DOCKET NOS. 50-266 AND 50-301
ASME SECTION XI, RELIEF REQUESTS
POINT BEACH NUCLEAR PLANT, UNITS 1 AND 2

In accordance with 10 CFR 50.55a(g)(5)(iii), Wisconsin Electric Power Company (licensee) requests inservice inspection relief for the second ten-year inspection interval for Point Beach Nuclear Plant, Units 1 and 2. Attachment 1 provides the supportive information for the relief requests from specific ASME Section XI code requirements for Unit 1. Attachment 2 provides the supportive information for the relief requests from specific ASME Section XI code requirements for Unit 2.

ATTACHMENT 1

UNIT 1 RELIEF REQUESTS

SUBJECT RESIDUAL HEAT REMOVAL HEAT EXCHANGER MADE BY SWP DATE 6/19/89
NOZZLE AREA - FIGURE 1 CHKD. BY _____ DATE _____

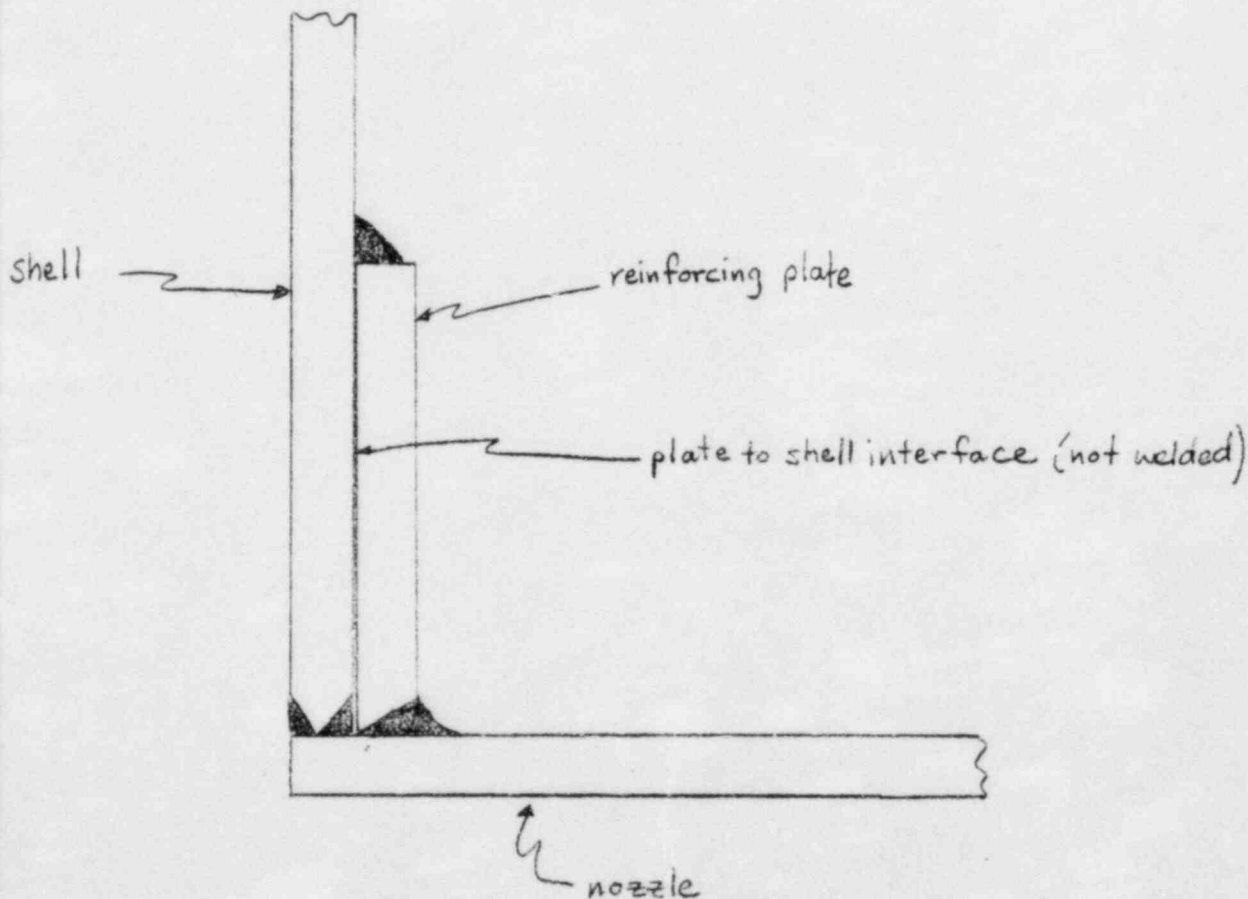
The volumetric examination is not possible due to the reinforcing plate configuration and inaccessibility to the vessel interior. The reinforcing plate is welded to the nozzle and shell and completely covers the nozzle-to-shell weld. Figure 1 shows the details of the nozzle-to-shell weld and welded reinforcing plate. The welded reinforcing plate by its size and space next to the nozzle outside diameter, prevents adequate UT coverage of the nozzle-to-shell weld. An ultrasonic signal transmitted at the plate surface would simply be reflected by the plate's backwall. The diameter of the reinforcing plate is such that

an ultrasonic wave propagated from the nearest shell or nozzle surface would not provide adequate coverage of the nozzle-to-shell weld. The best surface from which to examine the nozzle-to-shell weld is the inside surface of nozzle. But this area is not accessible without disassembly of the heat exchanger requiring approximately 40 man-hours of effort in a general area radiation field of 50-100 mRem per hour. The actual examination of the nozzle-to-shell weld from the inside surface of the RHR heat exchanger would require approximately 1 man-hour of effort in a radiation field of 35 Rem per hour for the "A" RHR heat exchanger or 12 Rem per hour for the "B" RHR heat exchanger. Based upon these configurations, the examination of the nozzle-to-shell weld by ultrasonics is impractical and contrary to ALARA concepts.

A surface examination will be performed on the entire reinforcing plate weld every 10 years. In addition, a visual (VT-2) examination for leakage will be conducted each inspection period during the system pressure test.

FIGURE B-3

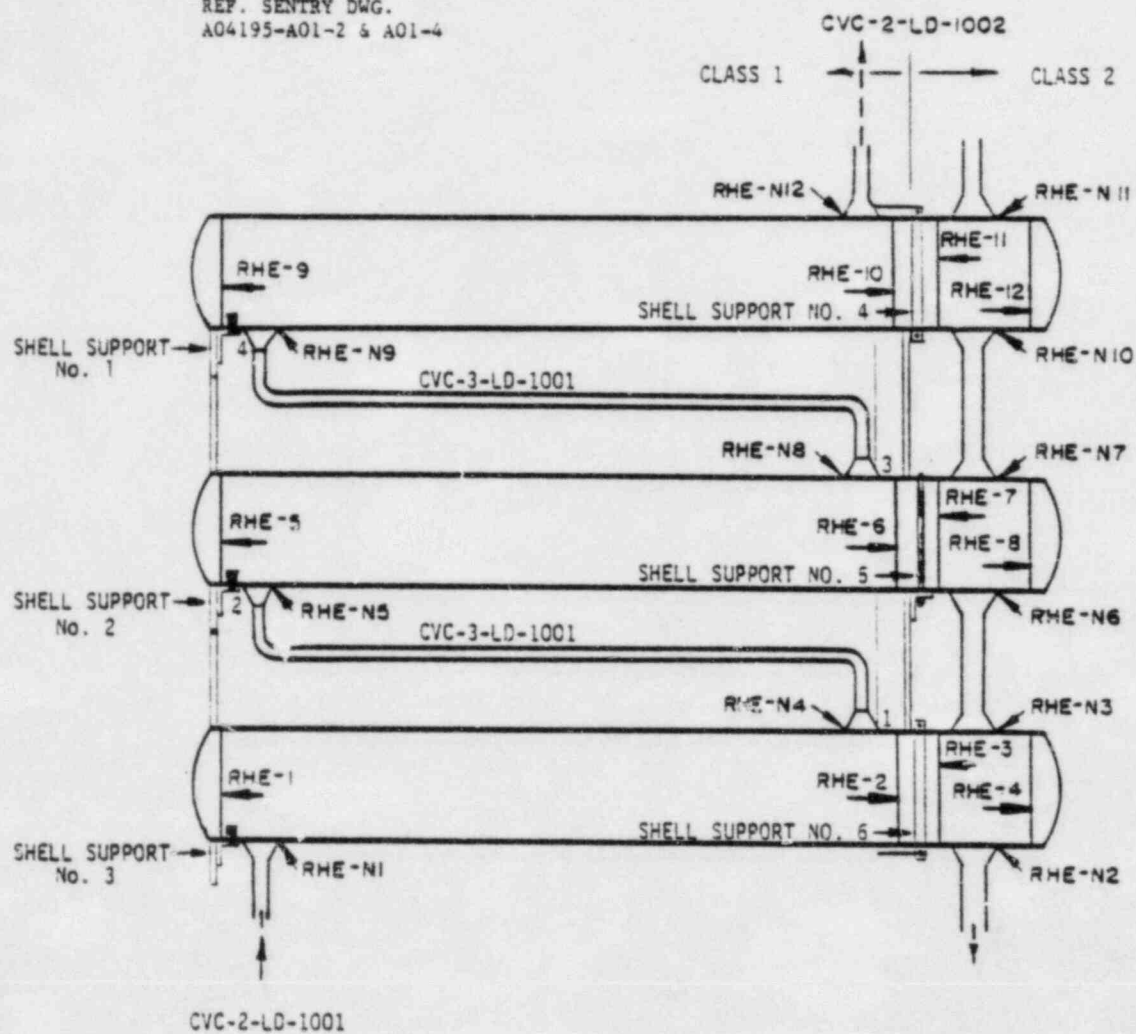
The attached drawing depicts the regenerative heat exchanger (RHE) with cross-sectional views of the nozzle areas. The side view illustration shows that the vessel surface is perpendicular to the nozzle axis. The end view illustration shows the relationship between the nozzle and the curved vessel surface. Therefore, the angle between the nozzle axis and the vessel surface is not constant around the circumference of the nozzle. Because of this complex nozzle/vessel geometry, constantly changing angles and examination parameters would be required to direct sound into the inner radius area. Since the nozzle and vessel diameters are both small, the changes in angles required would

be great and continually varying as the examination surface (shell surface) varies while scanning about the nozzle. Access to the examination surface is also restricted by circumferential shell welds which limit the extent of the examination.

In addition to the geometric considerations, the radiation field associated with this component is significant. Contact readings at the surface of the RHE nozzles before removal of the insulation are approximately 4R/Hr. The radiation field at 18 inches is approximately 1.5R/Hr. Contact readings after removal of insulation have been as high as 7R/Hr.

Considering the complexity of the geometry and the limitations on access all within the high radiation field associated with this component, the technique to conduct this exam would need to be so complex that unacceptable personnel radiation exposures would result. Therefore, a volumetric examination of these nozzle IRS's is impractical.

NOZZLE AREA - FIGURE 1 CHKD. BY _____ DATE _____

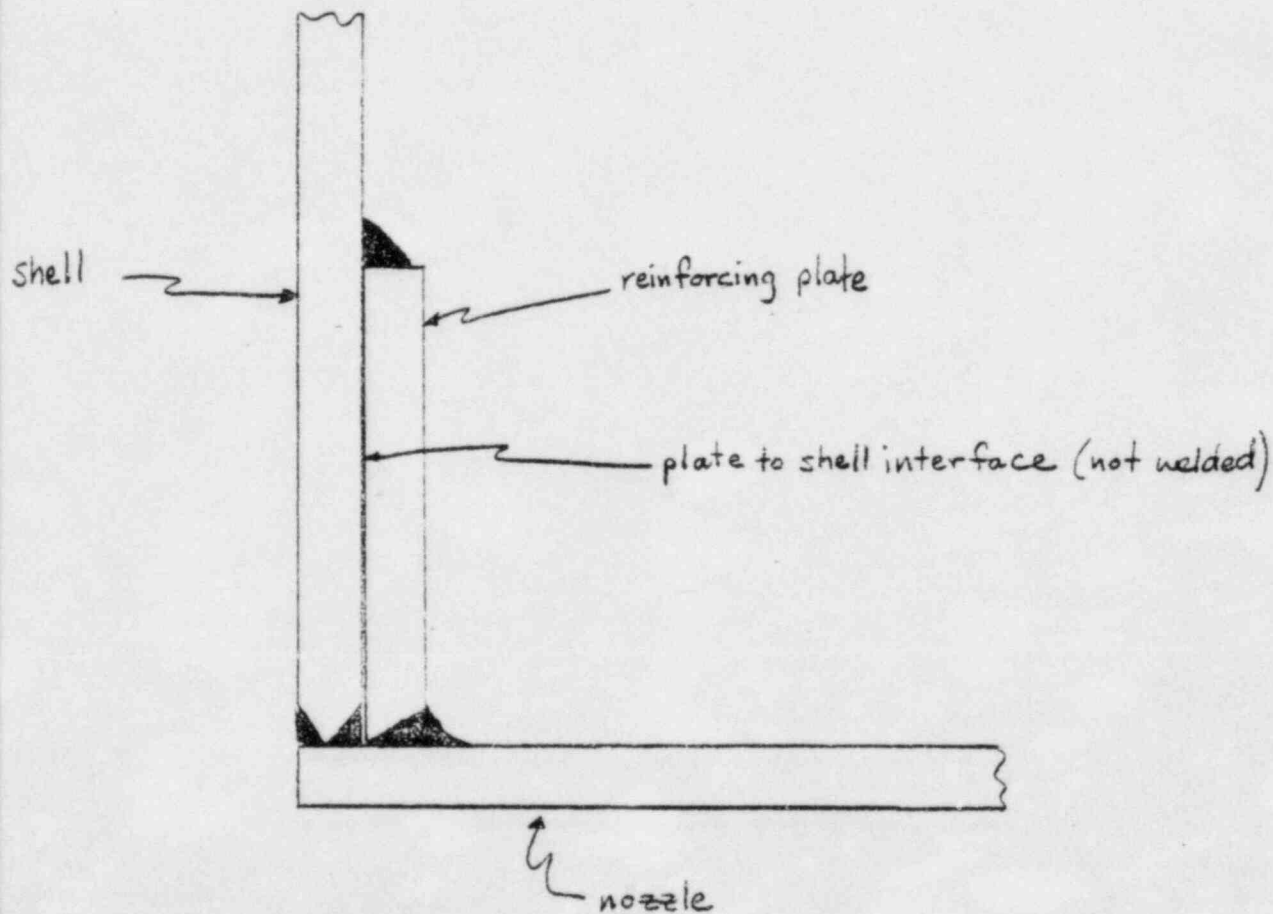
The volumetric examination is not possible due to the reinforcing plate configuration and inaccessibility to the vessel interior. The reinforcing plate is welded to the nozzle and shell and completely covers the nozzle-to-shell weld. Figure 1 shows the details of the nozzle-to-shell weld and welded reinforcing plate. The welded reinforcing plate by its size and space next to the nozzle outside diameter prevents adequate UT coverage of the nozzle-to-shell weld. An ultrasonic signal transmitted at the plate surface would simply be reflected by the plate's backwall. The diameter of the reinforcing plate is such that an ultrasonic wave

propagated from the nearest shell or nozzle surface would not provide adequate coverage of the nozzle-to-shell weld. The best surface from which to examine the nozzle-to-shell weld is the inside surface of nozzle. But this area is not accessible without disassembly of the heat exchanger requiring approximately 40 man-hours of effort in a general area radiation field of 50-100 mRem per hour. The actual examination of the nozzle-to-shell weld from the inside surface of the RHF heat exchanger would require approximately 1 man-hour of effort in a radiation field of 20 Rem per hour for the "A" RHR heat exchanger or 25 Rem per hour for the "B" RHR heat exchanger. Based upon these considerations, the examination of the nozzle-to-shell weld by ultrasonics is impractical and contrary to ALARA concepts.

A surface examination will be performed on the entire reinforcing plate weld every 10 years. In addition, a visual (VT-2) examination for leakage will be conducted each inspection period during the system pressure test.

FIGURE B-3

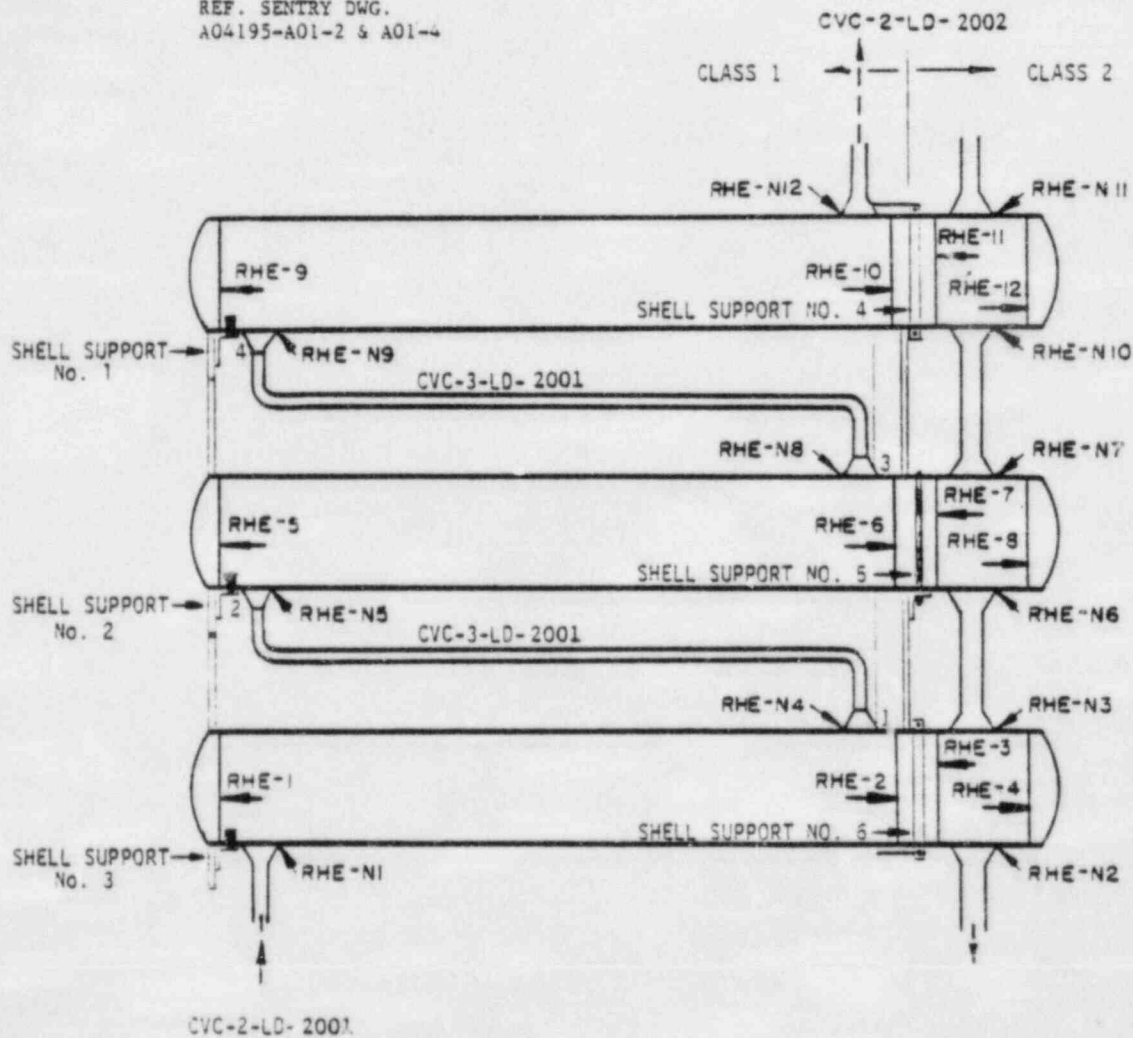
The attached drawing depicts the regenerative heat exchanger (RHE) with cross-sectional views of the nozzle areas. The side view illustration shows that the vessel surface is perpendicular to the nozzle axis. The end view illustration shows the relationship between the nozzle and the curved vessel surface. Therefore, the angle between the nozzle axis and the vessel surface is not constant around the circumference of the nozzle. Because of this complex nozzle/vessel geometry, constantly changing angles and examination parameters would be required to direct sound into the inner radius area. Since the nozzle and vessel diameters are both small, the changes in angles

be great and continually varying as the examination surface (shell surface) varies while scanning about the nozzle. Access to the examination surface is also restricted by circumferential shell welds which limit the extent of the examination.

In addition to the geometric considerations, the radiation field associated with this component is significant. Contact readings at the surface of the RHE nozzles before removal of the insulation are approximately 4R/Hr. The radiation field at 18 inches is approximately 1.5R/Hr. Contact readings after removal of insulation have been as high as 7R/Hr.

Considering the complexity of the geometry and the limitations on access all within the high radiation field associated with this component, the technique to conduct this exam would need to be so complex that unacceptable personnel radiation exposures would result. Therefore, a volumetric examination of these nozzle IRS's is impractical.
